**LOCAL HISTORIC DISTRICT:** Wilmore

**PROPERTY ADDRESS:** 1928 S. Mint Street

**SUMMARY OF REQUEST:** Front Porch

# Historic Commission Review

# Architectural Details – Columns

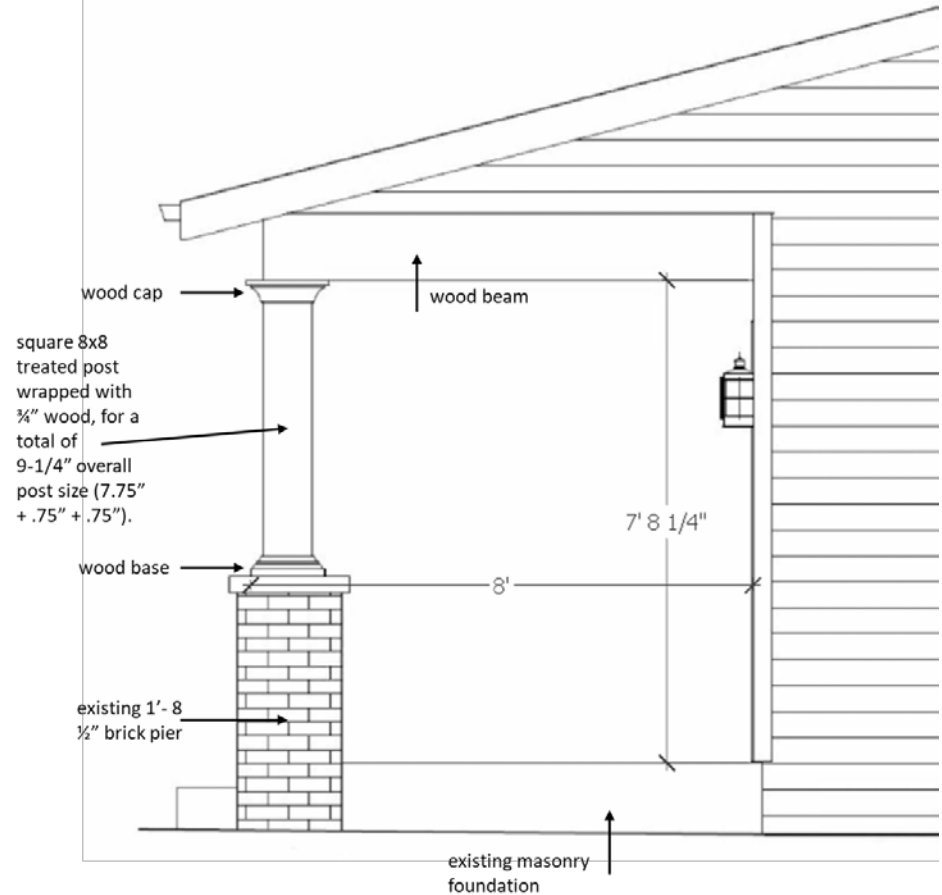
The proposal changes to the columns, ceiling and railing on the front porch. After removing the vinyl wrap, it was discovered that the front porch columns are not columns but pieces of wood assembled to create a base for the vinyl wrap. The proposed front porch columns are square 8x8 with a cap and base. The existing ceiling is plywood and requested to change to beadboard. The right-side of the porch will receive a new railing. Originally, only the right-side had, and needed, a railing. All materials to be wood.
